Subject: IL 2 (Byron to Rockford) PSG Meeting #6

BMcD Project No.: 127815

Meeting Date: October 6, 2021

Project Study Group Meeting #7

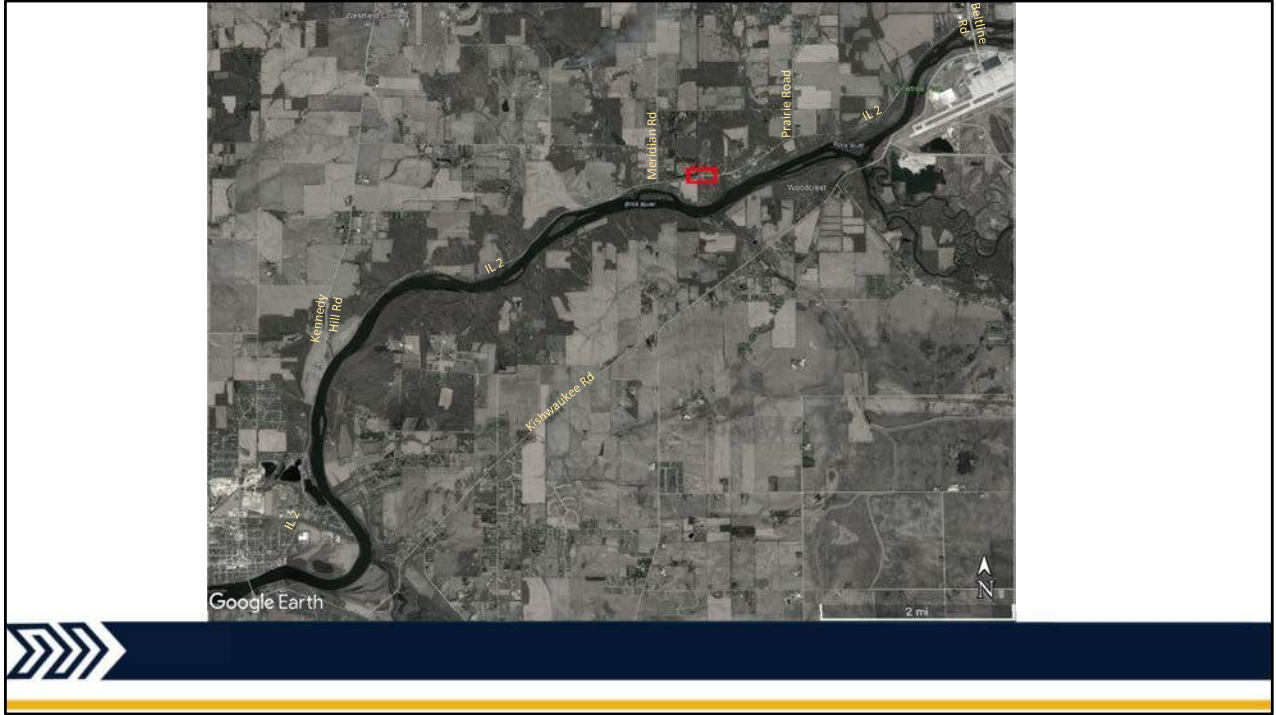
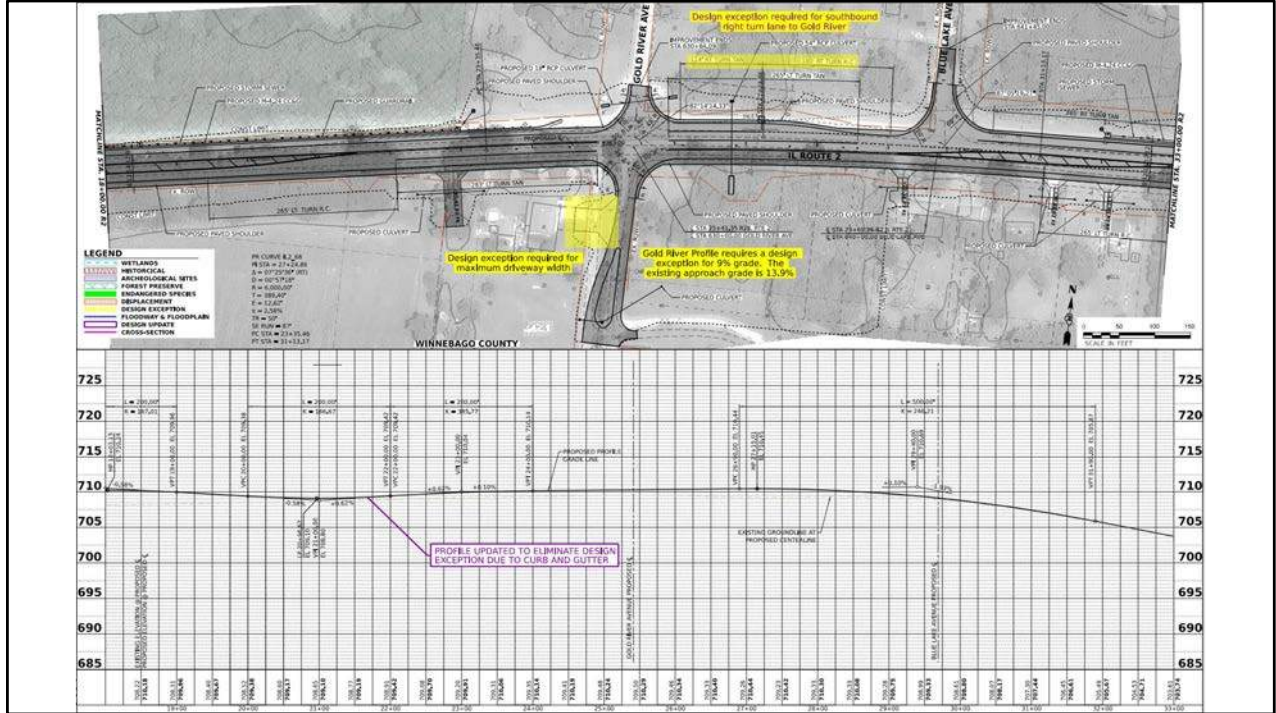
- Design exceptions will be formally presented at a future bi-monthly meeting.
 - At the Winnebago Forest Preserve property IDOT inquired if the extend of the limits can be reduced to remain within the IDOT ROW or minimize work in the forest preserve property. [BMcD indicated the profile may be able to be adjusted to lower the profile so the parkway beyond the back of curb and in the IDOT ROW can be slope towards the roadway.](#) IDOT indicated the depressional areas on the forest preserve property do not need to have positive drainage, therefore, the swale behind the back of curb can be eliminated. Mark Nardini and Felecia Hurley preferred this approach.

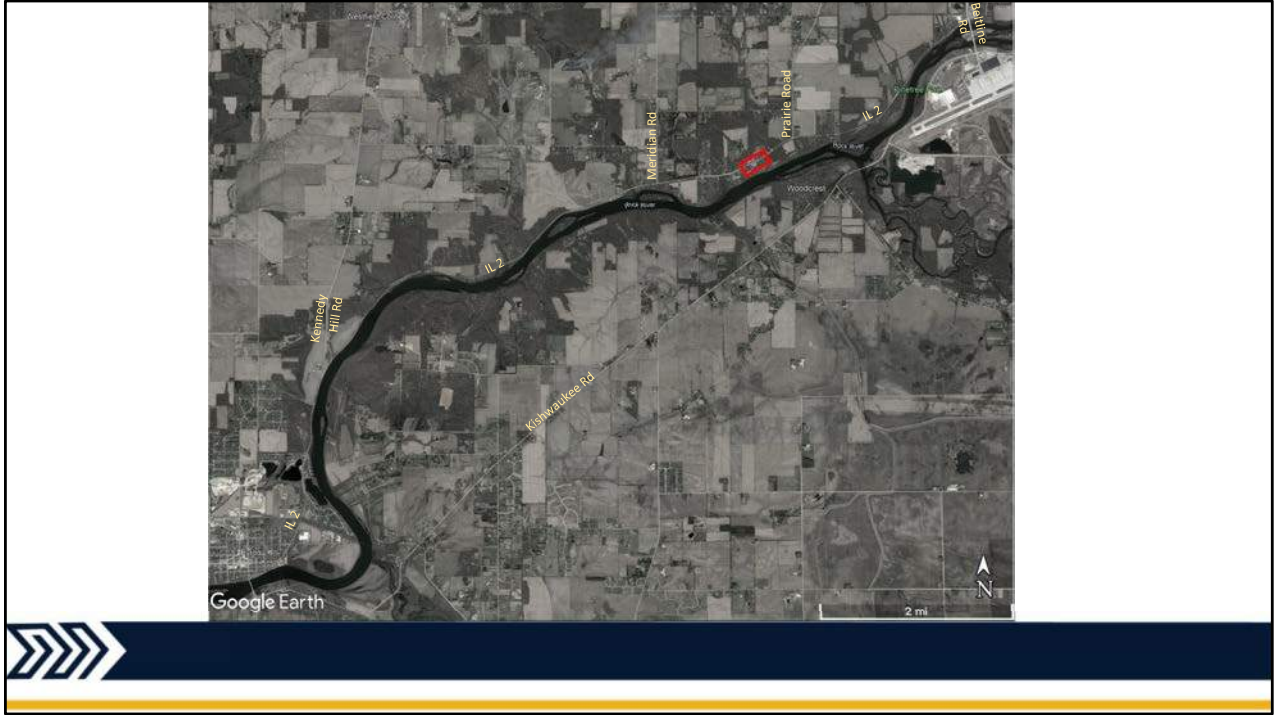
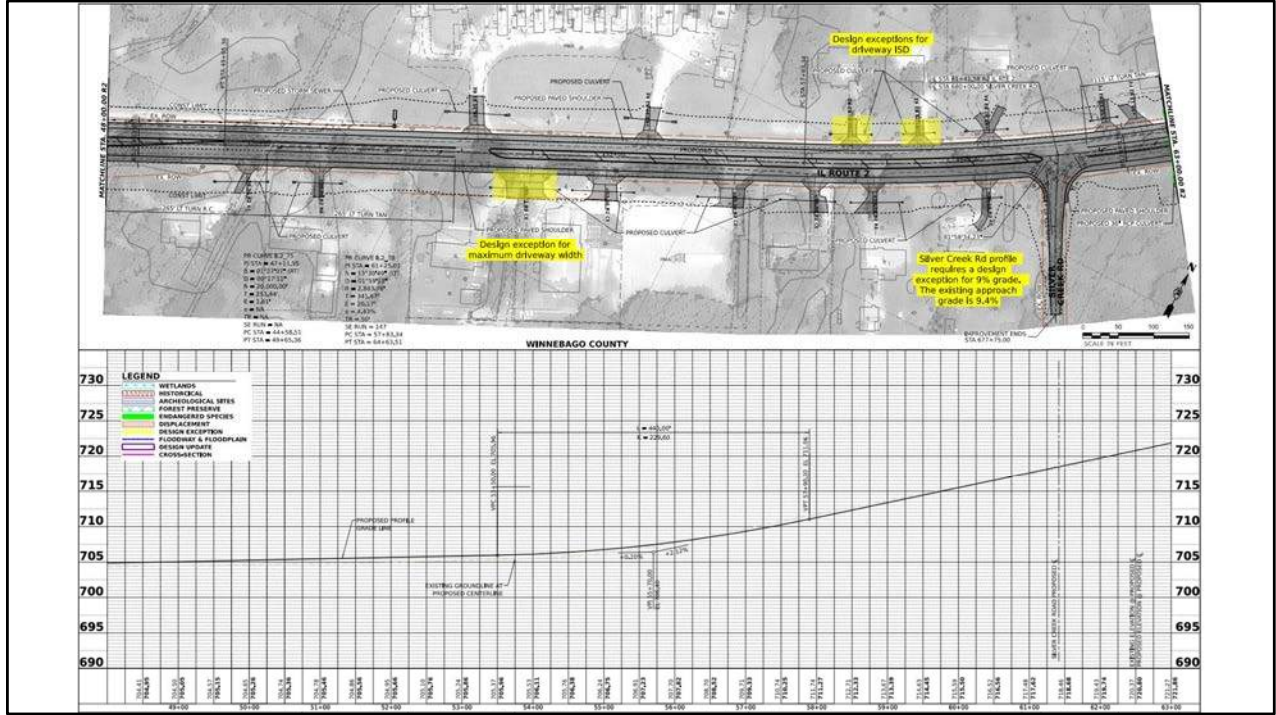
- IDOT inquired if turn lanes were considered at the entrances to the Blue Star Rest Area to be consistent with the rest of the corridor. [BMcD and IDOT will evaluate the installation of turn lanes.](#)

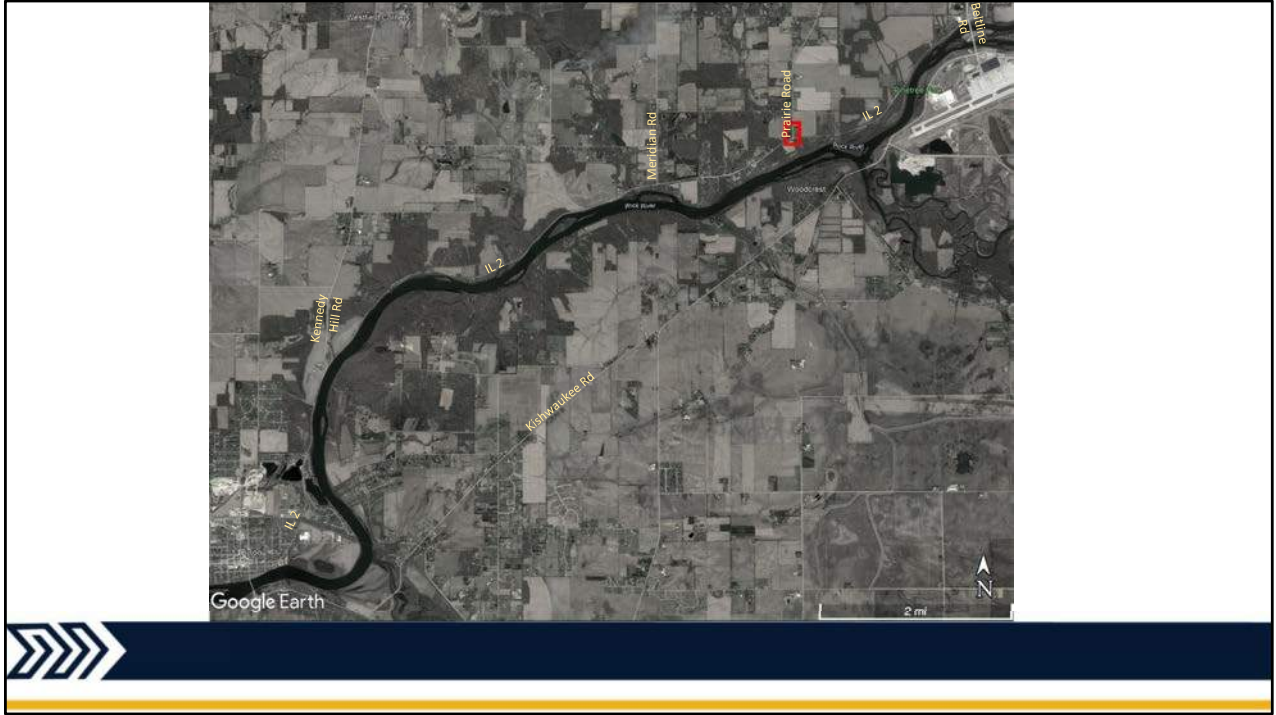
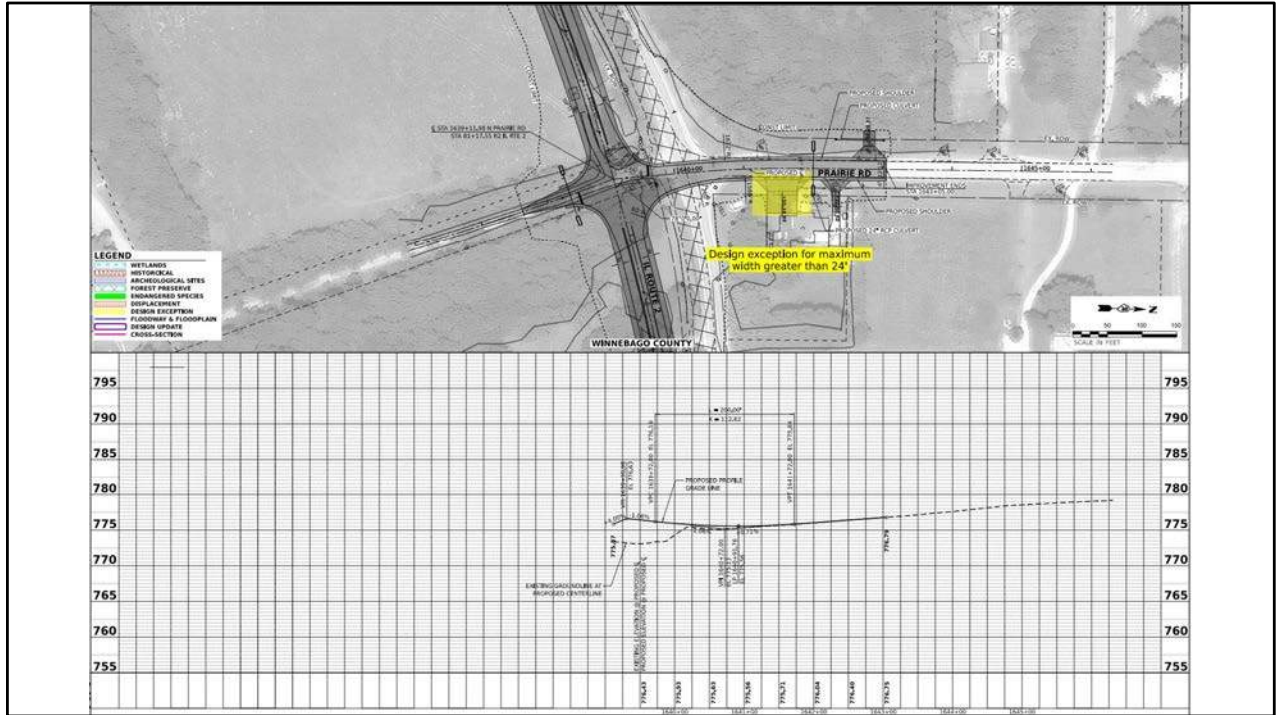
- IDOT inquired if right turn lanes were considered Prairie Road to be consistent with the rest of the corridor. The south leg of Prairie Road is a low volume dirt road and will not likely have a dedicated right turn lane, but this will be considered for the north leg. [BMcD will coordinate with IDOT on this item.](#)

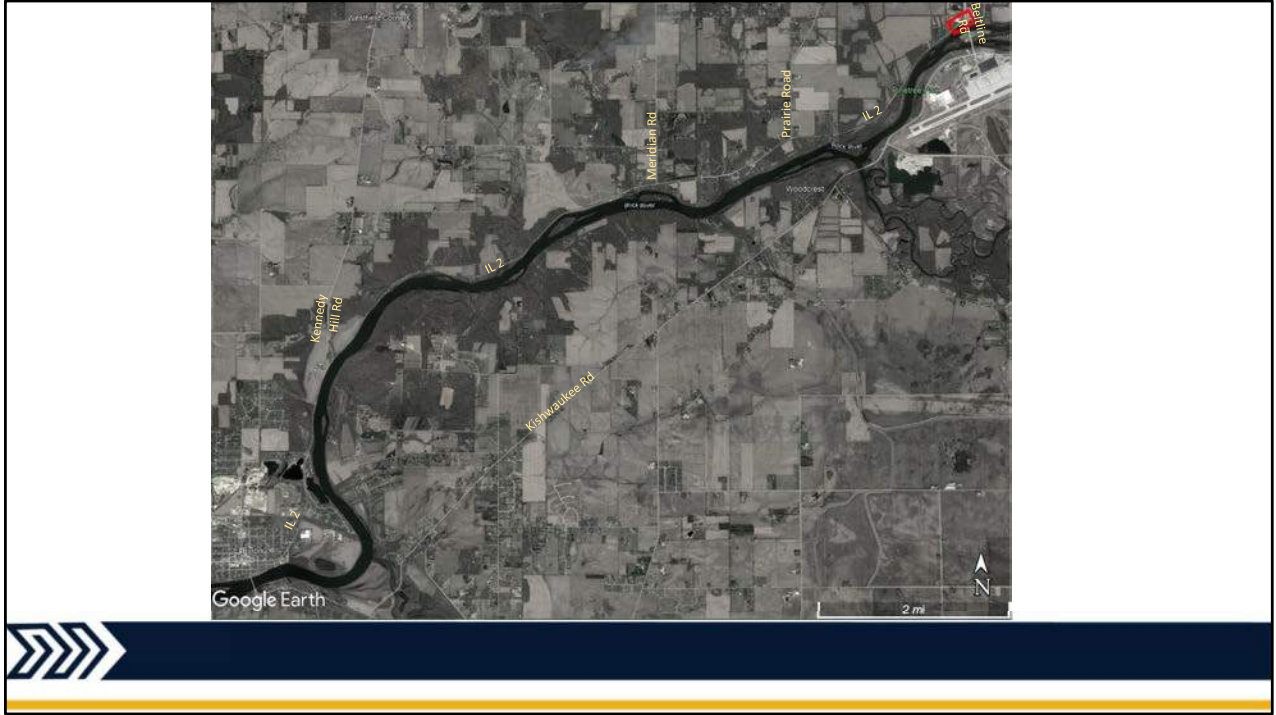
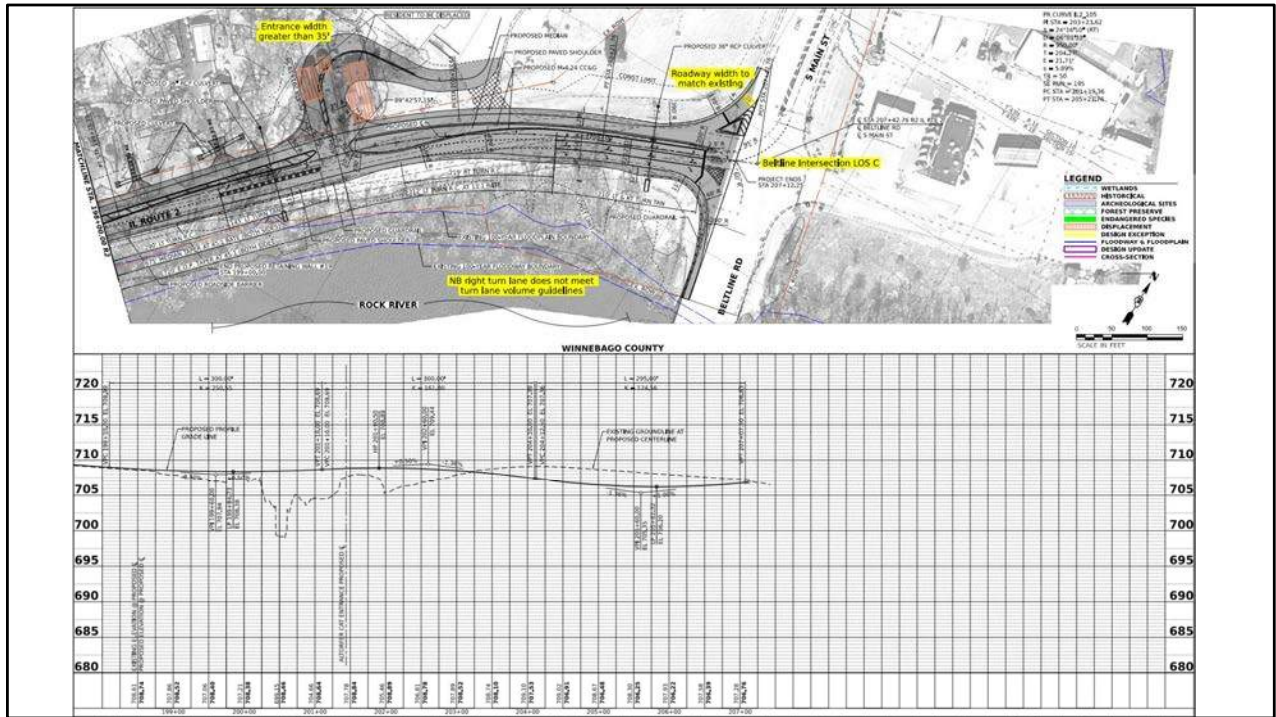
- Jon Estrem indicated the construction limits west of the new entrance to the Patten Equipment Dealership on the NW corner of Beltline Road will require the acquisition of the residential house. Jon indicated the ROW need to be at least 10 feet from the house to avoid the acquisition. [BMcD will evaluate changes to the drainage and ditches in this area to determine if the acquisition can be avoided.](#)
